UNITED STATES PATENT AND TRADEMARK OFFICE

APPLICATION NO.	FILING DATE	FIRST NAMED INVENTOR	ATTORNEY DOCKET NO.	CONFIRMATION NO.
10/515,980	07/06/2005	Hideaki Watanabe	029567-00003	2588
4372	7590	08/10/2007	EXAMINER	
ARENT FOX PLLC			PILKINGTON, JAMES	
1050 CONNECTICUT AVENUE, N.W.				
SUITE 400			ART UNIT	PAPER NUMBER
WASHINGTON, DC 20036			3682	
			MAIL DATE	DELIVERY MODE
			08/10/2007	PAPER

Office Action Summary	Application No.	Applicant(s)
	10/515,980	WATANABE ET AL.
	Examiner	Art Unit
	James Pilkington	3682

DETAILED ACTION

Taken from Strasburg Figure 1

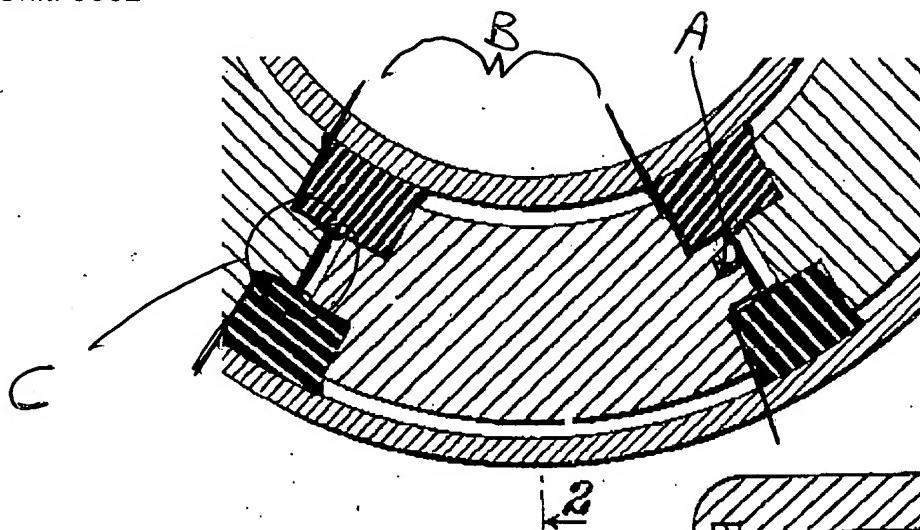
Re clm 3, Strasburg discloses that the connecting means of each ring piece includes a protruding piece (A, see Figure below) formed in one end of the ring piece (B, combination of 10 and 11) and a hole formed in the other end (C) of the ring piece (B), and said ring pieces are bonded in a circumferential direction by close-fitting the protruding piece (A) of one of the ring pieces (B) adjacent in a circumferential direction into the hole of the other one of the adjacent ring pieces.
